ADDENDUM #001

Client: Clermont County Park District
Project: Kathryn Stagge-Marr Park Shelter

A1 SECTION AT COLUMN **MODIFIED PER ADDENDUM 1**
1" = 1'-0"

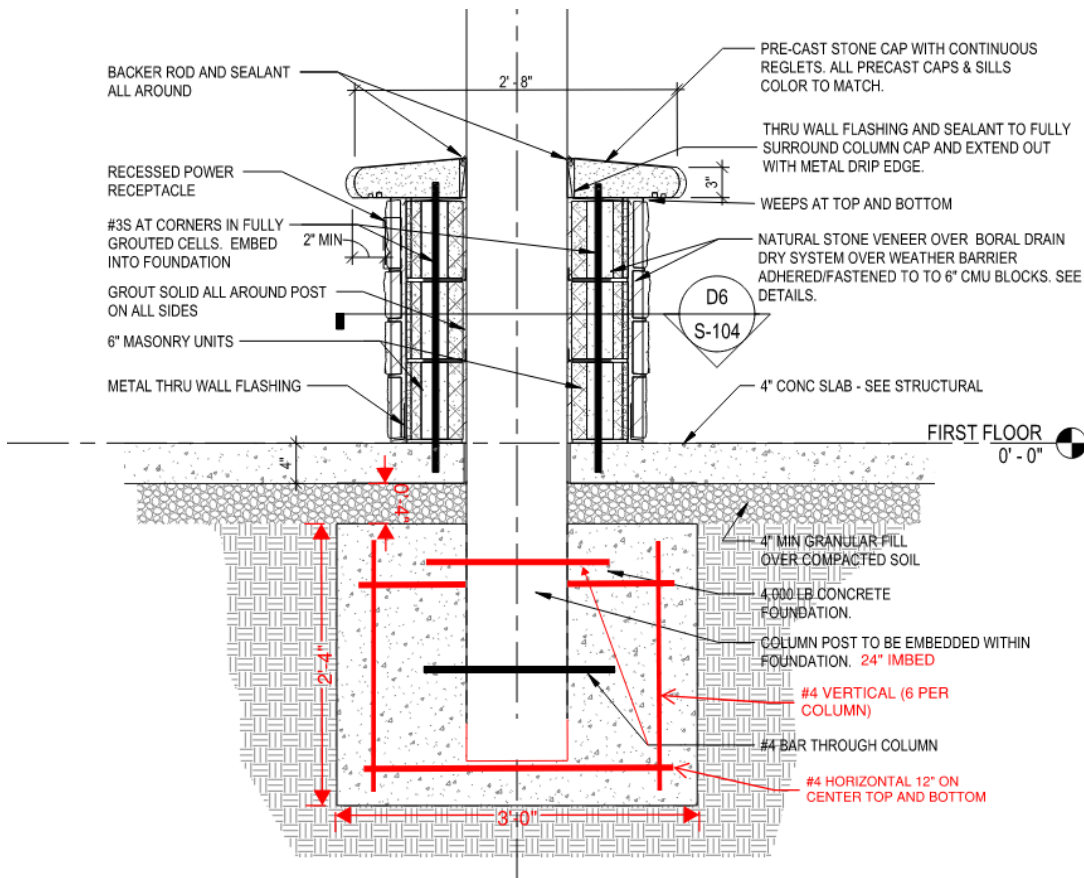
1. See attached sketch of the foundation portion of A1 on S-104 SECTION AT COLUMN. This section is revised to show detail and dimensions at the column foundation.
2. The contractor shall provide vented soffit at the gutter side overhang and continuous ridge vents.
